GOVERNMENT OF THE DISTRICT OF COLUMBIA
OFFICE OF PLANNING

MEMORANDUM

CASE NO. 05-23

SUBJECT: Final Report – Zoning Commission Case No. 05- 23, Square 3576, Lot 815
A Proposed Consolidated Planned Unit Development (PUD) With Related Map
Amendment at Eckington Place and Harry Thomas Way, N.E.

Landscaping – Building 1

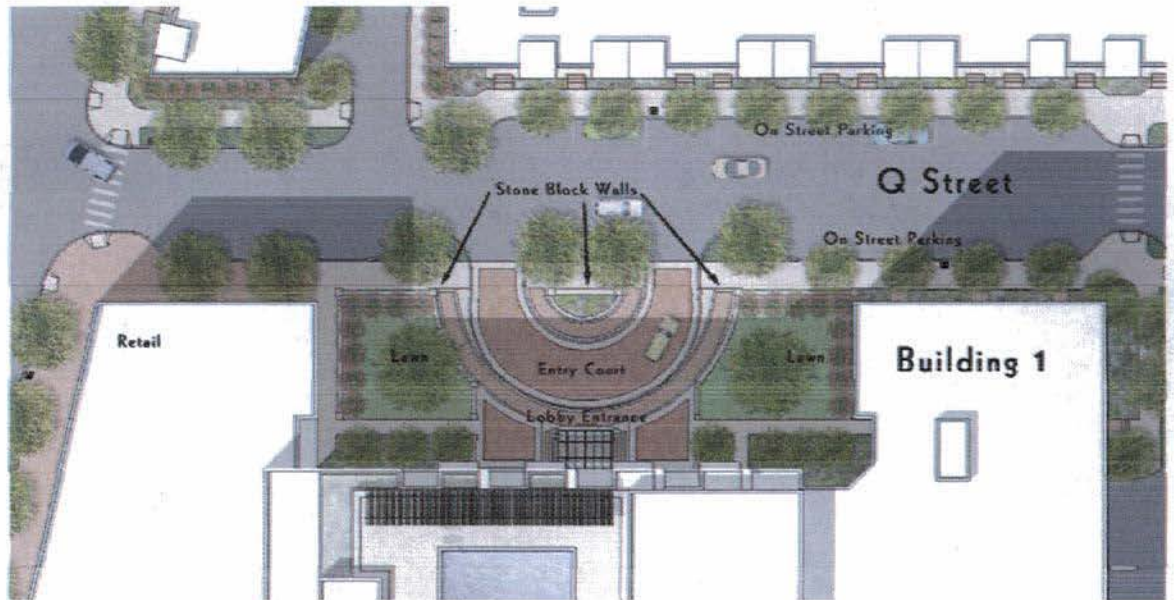
The buildings on the south side of Q Street will have front lawns, framed by the building wings, with a U-shaped drop-off. OP has strongly encouraged the applicant to provide a defining wall that will separate public from private space and give a greater sense of streetscape continuity on the south side. The high-rise building on the north side of Q Street will also have a generous lawn, devoted primarily to private recreation space. There will also be a small public sitting area with benches adjacent to the Q Street sidewalk. This will be privately maintained.

- Response: Addressed. (See Attachment 5)
- Design of public area on north side of Q Street
 - Response: Addressed
- Design of arched parking access beneath second story of Q Street duplex townhouses
